*LUCAS COUNTY
PLAN COMMISSION
REPORT*

December 17, 2014

3. S-20-14: Preliminary Drawing Review of CARRIETOWNE NORTH PLAT THREE, at Central Avenue and McCord Road (jl)

4. Z17-C346: Zone Change from A/R, C-1 and C-2 to C-3 PUD at Brandyway Lane and Salisbury Road (jl)

PUD/ PRELIMINARY DRAWING

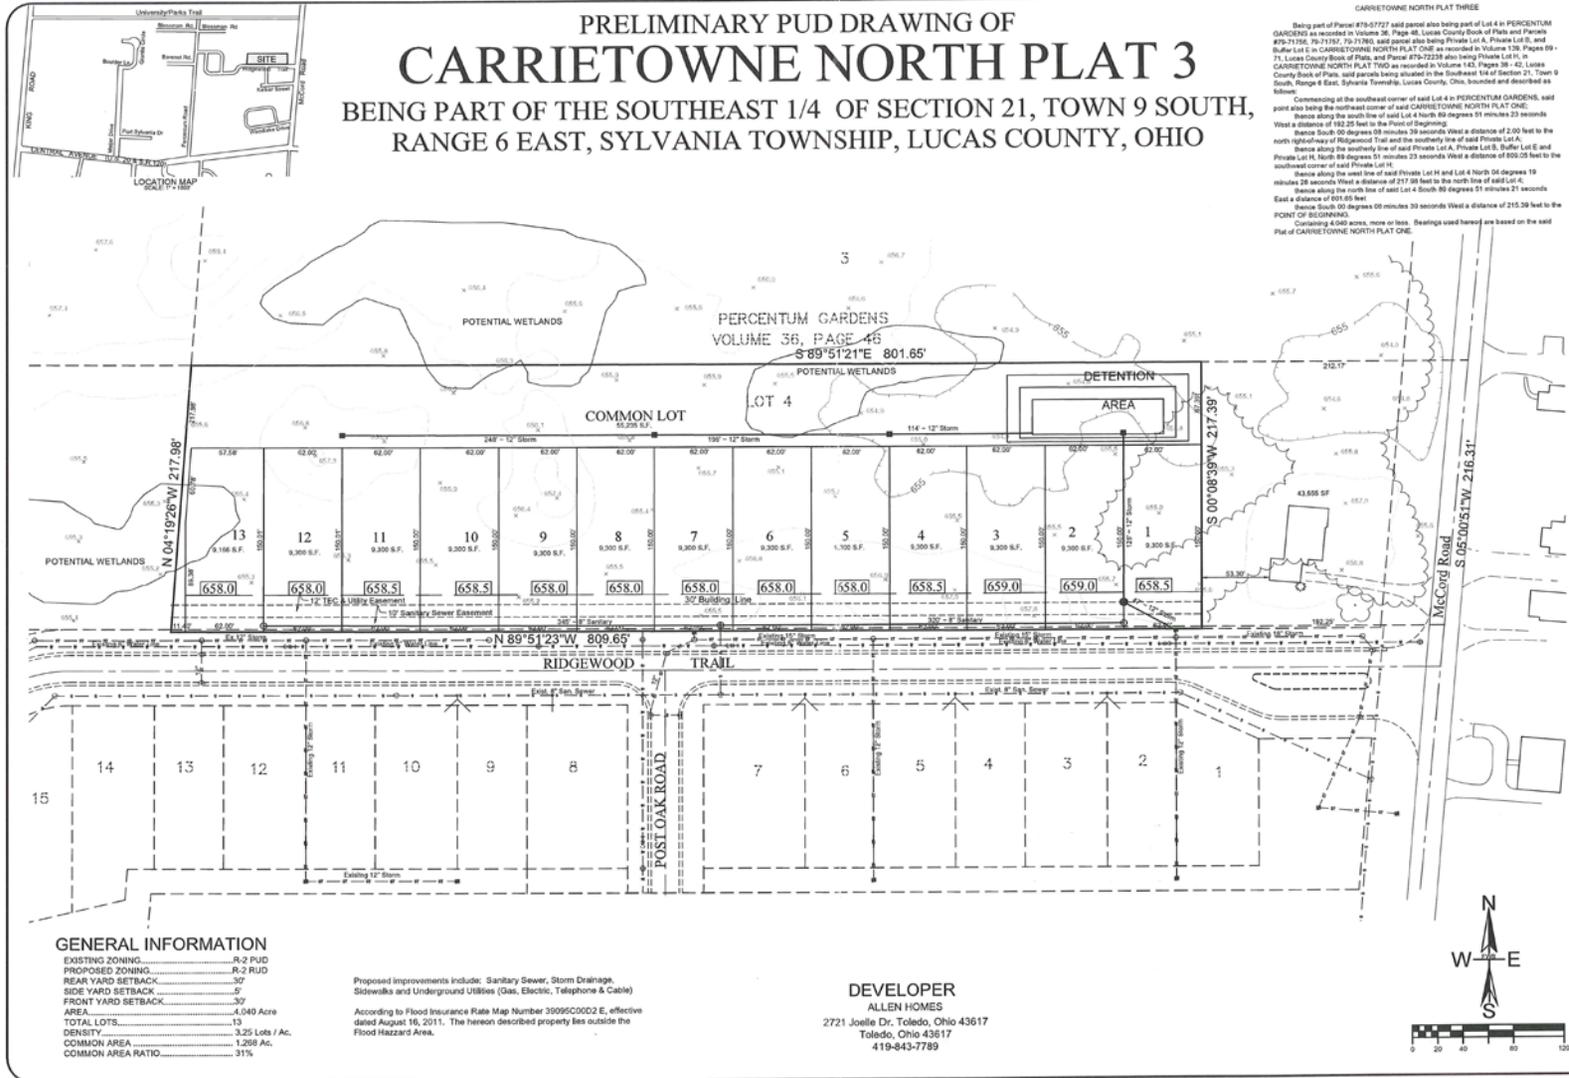
Each of the proposed thirteen lots include 60’ feet of width and 9,300 sq.ft. of area. The proposed lots will have access to existing Ridgewood Trail. There are currently two foot buffer lots and a two foot no access lot across from Post Oak Road. The buffer lots were created by the developer of CARRIETOWNE NORTH PLATS ONE and TWO to prevent access to Ridgewood Trail. The developer submitted documentation demonstrating their ability to acquire those lots and provide access for the development. The no access lot may only be removed by extending the right-of-way. If a stub street is not extended then the elimination of this lot shall be addressed.

All lots meet zoning requirements. However, Lots 7 & 8 include a portion of the two foot no access lot that was created to prevent access from northerly lots until the right-of-way of Post Oak Road was extended. The proposed layout does not dedicate any additional right-of-way to remove the lot. The Lucas County Subdivision Rules and Regulations, *Sec. 507.f*, also require that any subdivisions with adjacent undeveloped land create stub streets to connect future development. The site has undeveloped land to the north and west. A waiver of the stub street to the north is not supported by staff unless a detailed wetland delineation is conducted indicating the presence of wetlands that would prohibit the extension of Post Oak Road to the north. A waiver of the stub to the west is supported by staff because of the narrow parcel width and proposed orientation of the subdivision. The stub street is included as a condition of approval. The roadway extension to the north would require the reconfiguration of the proposed subdivision lots.

1. Water is available to this site via existing waterline W-1476-8" along Ridgewood Trail and sewer is available to this site via existing sanitary sewer S-774-8" along Ridgewood Trail and shall be labeled as such.

2. The proposed sewer shall be labeled as S-774C-8". This shall also be on the title sheet in the title.
3. Water main taps and services shall be installed at time of construction by City of Toledo – Division of Water and shall meet their standards and specifications. The City of Toledo shall install these taps at the contractor's/owner's expense.

14. A site grading plan for the project shall be submitted to the Lucas County Engineer's Office for approval as a part of the paving and storm drainage plans.
15. The proposed storm sewer mainline in the rear of the lots is not desirable for future maintenance access. If the storm sewer is located in the rear of the lots, a designated and useable access easement and route will be required such that heavy equipment will be able to reach the storm sewer for routine cleaning and maintenance. Rear drainage swales and easements will be required in accordance with Lucas County Drainage Standards.
16. A twenty (20) foot wide drainage easement shall be platted for the storm sewer between Lots 1 & 2.
17. Footer tile outlets shall be provided to all lots unless basements and crawls are prohibited by a plat recitation.

19. The proposed preliminary plat drawing shows potential wetlands and the developer's consultant has submitted a wetland delineation and documentation to the U.S. Army Corps of Engineers for review. Prior to any filling or disturbing these areas, the owner or consultant shall wait for a response from the U.S. Army Corps of Engineers to determine if any permits are required from them or others agencies prior to such activity.

- b. The storm water detention area should be constructed on a separate, non-buildable lot with an easement for access. As shown on the drawing, there is no designated means of access to the detention area for future maintenance and one shall be provided. Plat recitations and deed covenants will be required to address ownership and maintenance of detention area, and to prohibit filling, alteration and obstruction of the area.

26. Per Lucas County Subdivision Rules and Regulations Sec. 507.f, a stub street shall be required for the undeveloped land to the north unless a wetland delineation identifies the presence of wetlands that would prohibit development to the north. (Also included as a condition of S-20-14.)
27. Documentation shall be submitted indicating the presence of any wetlands on the property. Any wetlands identified within the subdivision shall be included on a Final Plat.
28. Sidewalks shall be installed along Ridgewood Trail for the entire parcel, including the area abutting the single family residence. The developer is encouraged to fully extend and connect the sidewalk to west. (Also included as a condition of S-20-14.)

PUD/ PRELIMINARY DRAWING

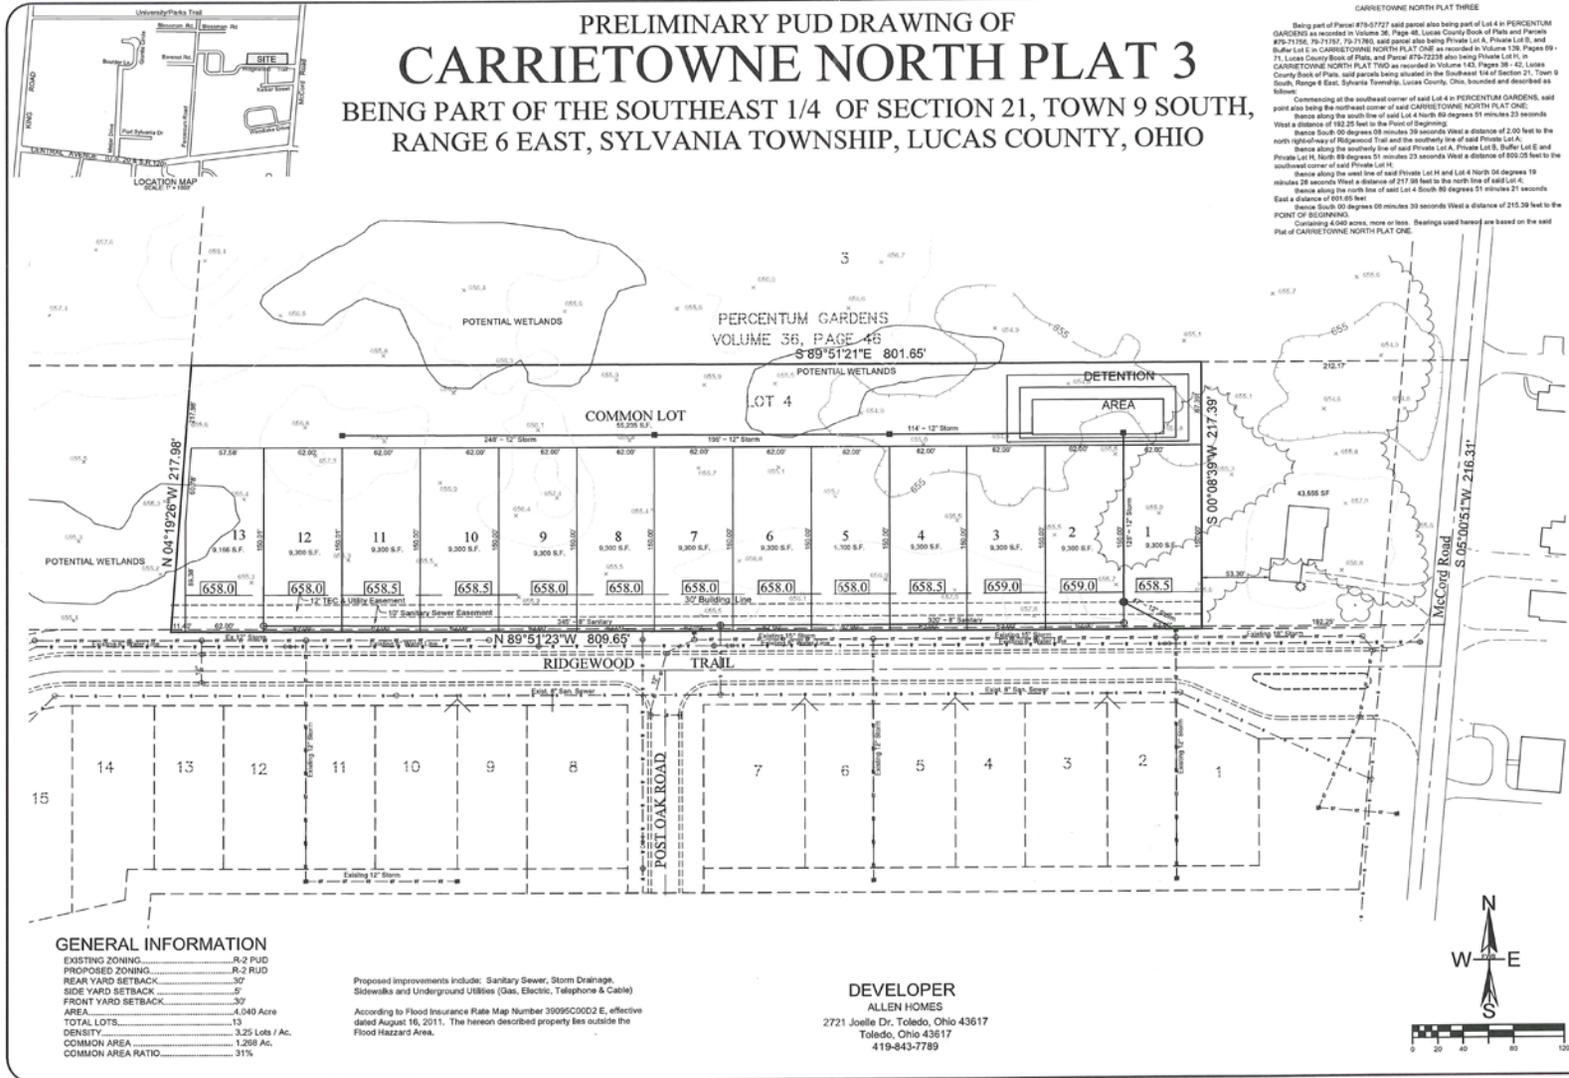
Each of the proposed thirteen lots include 60’ feet of width and 9,300 sq.ft. of area. The proposed lots will have access to existing Ridgewood Trail. There are currently two foot buffer lots and a two foot no access lot across from Post Oak Road. The buffer lots were created by the developer of CARRIETOWNE NORTH PLATS ONE and TWO to prevent access to Ridgewood Trail. The developer submitted documentation demonstrating their ability to acquire those lots and provide access for the development. The no access lot may only be removed by extending the right-of-way. If a stub street is not extended then the elimination of this lot shall be addressed.

All lots meet zoning requirements. However, Lots 7 & 8 include a portion of the two foot no access lot that was created to prevent access from northerly lots until the right-of-way of Post Oak Road was extended. The proposed layout does not dedicate any additional right-of-way to remove the lot. The Lucas County Subdivision Rules and Regulations, *Sec. 507.f*, also require that any subdivisions with adjacent undeveloped land create stub streets to connect future development. The site has undeveloped land to the north and west. A waiver of the stub street to the north is not supported by staff unless a detailed wetland delineation is conducted indicating the presence of wetlands that would prohibit the extension of Post Oak Road to the north. A waiver of the stub to the west is supported by staff because of the narrow parcel width and proposed orientation of the subdivision. The stub street is included as a condition of approval. The roadway extension to the north would require the reconfiguration of the proposed subdivision lots.

1. Water is available to this site via existing waterline W-1476-8" along Ridgewood Trail and sewer is available to this site via existing sanitary sewer S-774-8" along Ridgewood Trail and shall be labeled as such.

2. The proposed sewer shall be labeled as S-774C-8". This shall also be on the title sheet in the title.
3. Water main taps and services shall be installed at time of construction by City of Toledo – Division of Water and shall meet their standards and specifications. The City of Toledo shall install these taps at the contractor's/owner's expense.

19. The proposed preliminary plat drawing shows potential wetlands and the developer's consultant has submitted a wetland delineation and documentation to the U.S. Army Corps of Engineers for review. Prior to any filling or disturbing these areas, the owner or consultant shall wait for a response from the U.S. Army Corps of Engineers to determine if any permits are required from them or others agencies prior to such activity.

- b. The storm water detention area should be constructed on a separate, non-buildable lot with an easement for access. As shown on the drawing, there is no designated means of access to the detention area for future maintenance and one shall be provided. Plat recitations and deed covenants will be required to address ownership and maintenance of detention area, and to prohibit filling, alteration and obstruction of the area.

27. Per Lucas County Subdivision Rules and Regulations **Sec. 507.f**, a stub street shall be required for the undeveloped land to the north unless a wetland delineation identifies the presence of wetlands that would prohibit development to the north.

PUD DRAWING

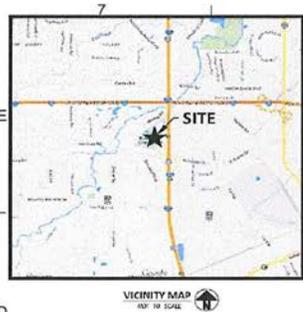
The plan includes a 3-story, 140,000 sq. ft., office building centrally located on the 55 acres and a 743 space parking lot located on the east of the site closest to the highway. The central location on the site and access from Salisbury Road will minimize impacts to adjacent uses. A building in C-3 zoning is limited to three stories and forty five feet in height. Architectural review of the building is required and included as a condition of approval.

The plan indicates that the site will be accessed from Salisbury Road through a proposed realignment of Brandyway Lane with Briarfield Boulevard. An emergency only connection is also provided to the existing Brandyway Lane. The applicant currently does not have the land secured in order to accomplish the realignment. If the acquisition of land is not successful there are two additional options for access: one using the existing Brandyway Lane and one using frontage along Manley Road. Staff has concerns with access along Manley Road. However, because the project is bound by the approved plan, any major changes such as changes to access will require review again through the Zone Change / Planned Unit Development process.

A landscape plan is not provided for the project at this time. Landscaping is required along all road frontages, around all parking areas visible from the right-of-way, and adjacent to any "A" or "R" district. When adjacent to either of those districts landscaping shall be a minimum of six feet to help shield the non-residential use from view. A detailed landscape plan is included as a condition of approval.

14. The rezoning plan submitted shows offsite improvements including the proposed extension of Briarfield Blvd. to the site as a primary means of access and reconfiguring Brandyway Lane to connect to the extension of Briarfield Blvd. The following are comments relative to these offsite improvements:

- 17. Suggest using pervious type grass pavers or similar pervious materials for the gated emergency access driveway.
- 18. Provide 25 foot minimum radii at the Briarfield Blvd. extension and relocated Brandyway intersection and 35 foot minimum radii at the Briarfield Blvd. extension at Salisbury Rd.
